**3.6.2 Environmental Consequences****3.6.2.1 Proposed Action**

During the 74-day public comment period on the Three Oaks Mine Draft EIS, the USACE received 88 comment letters. The letters are reproduced in their entirety in Appendix H of this Final EIS. Each comment is identified by a bracket and a letter and comment number (e.g., comment 3-4 refers to the fourth comment in letter 3). The response to each comment accompanies the letter and is identified by the reference number of the respective comment (e.g., response to comment 3-4).

Figure 4-1. Adjusted PRB Fuel Costs FOB to Alcoa Rockdale Plant - Actual Data 1996 through June 2001  
(Adjusted for Rail Haulage Differential)

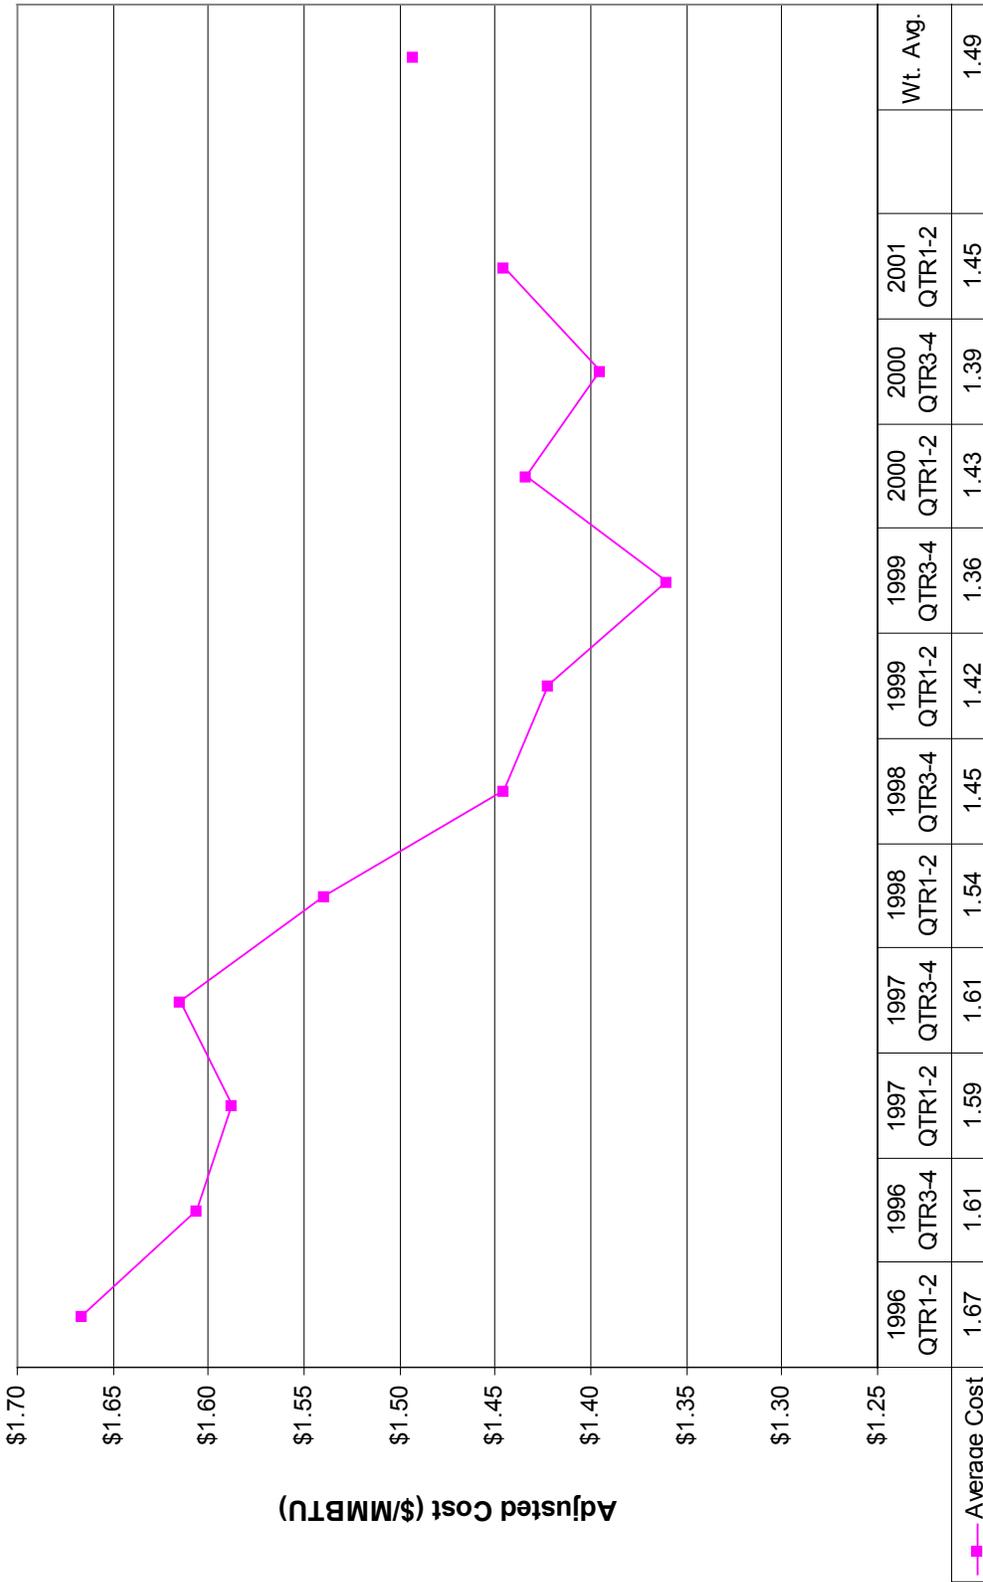
Comment – The Draft EIS does not provide adequate economic justification for Alcoa's proposed continuation of lignite use at Rockdale as opposed to other fuels and fails to consider the potential savings and social benefits including reduced ash disposal costs, reduced mine power consumption, and improved air quality that could result from a switch to western coal or natural gas. The fuel cost comparison does not use current cost data.

Response – Section 2.4.1 of the Draft EIS includes a discussion of various alternatives available to Alcoa that would not require construction of the Three Oaks Mine. The EIS is not intended to provide a comprehensive economic analysis of Alcoa's mine, generating unit, and smelter operations, but rather to evaluate Alcoa's assertion that mining of local lignite represents the only practical option for generating the power necessary to maintain smelter operations at the Rockdale facility. On this basis, Section 2.4.1 presents the relative costs of alternative fuels available to Alcoa along with the estimated costs, where appropriate, for converting the facilities to use such fuels, and the advantages/disadvantages associated with each fuel type. Any comparison of this type represents a snapshot view at a particular point in time using data from sources available at that time. Obviously, the various fuel costs have continued to change since the 1999 to 2000 timeframe on which most of the costs presented in this section are based. Most of the changes over the past 2 years, however, tend to reinforce Alcoa's assertions regarding: 1) the instability of natural gas prices and 2) the price differentials between lignite and either western coal or natural gas. For example, data available on the Energy Information Administration webpage (<http://www.eia.doe.gov>) show natural gas prices to electric utility customers in Texas peaked in January 2001 at the equivalent of \$8.74/MMBTU with an increase in annual average from \$2.93 in 2000 to \$5.80 in 2001. The average prices to industrial consumers generally parallel those for electric utilities.

The projected delivered prices by contract were weighted by volume to calculate a weighted average by quarter for the 5.5-year history evaluated. Review of the adjusted delivered price shows that projected weighted average pricing declined from approximately \$1.67/MMBTU in the first half of 1996 to approximately \$1.36/MMBTU in the last half of 1999 and then increased to approximately \$1.45/MMBTU in the first half of 2001 (see **Figure 4-1**). The overall weighted average for the 5.5-year period was approximately \$1.49/MMBTU.
